Supporting information for D1.1 comments* on chromatic dispersion specifications

John Johnson, Broadcom

* Reference D1.1 comments #18-29.

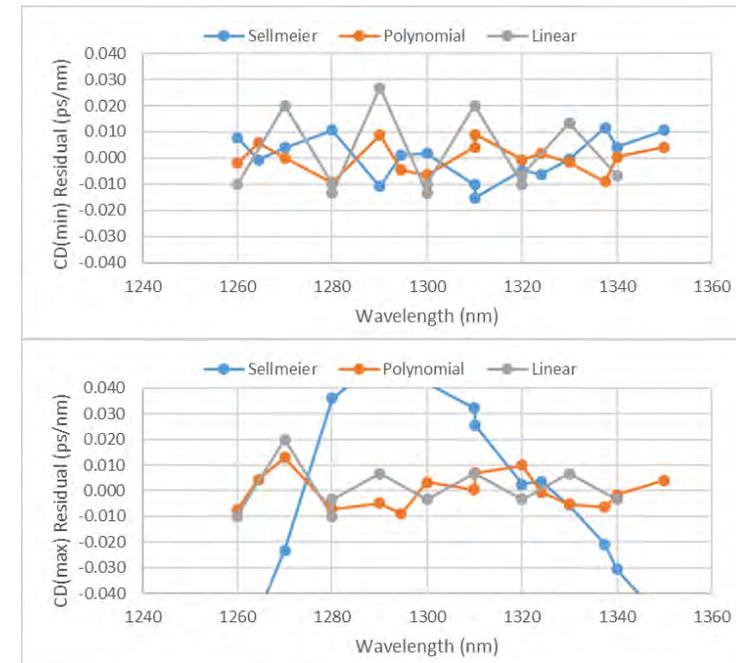
- The residual errors of the fits to the tabulated data points are compared below.
- The Sellmeier fit for $CD(\max)$ is poor due to irregular distributions for $M = 1$ with $Q = 99.9\%$.
- The polynomial and linear fits both give low residual errors that are $< \pm 0.03$ ps/nm across the band.
- Propose using linear fits per channel for FR4, and Sellmeier fits for LR4
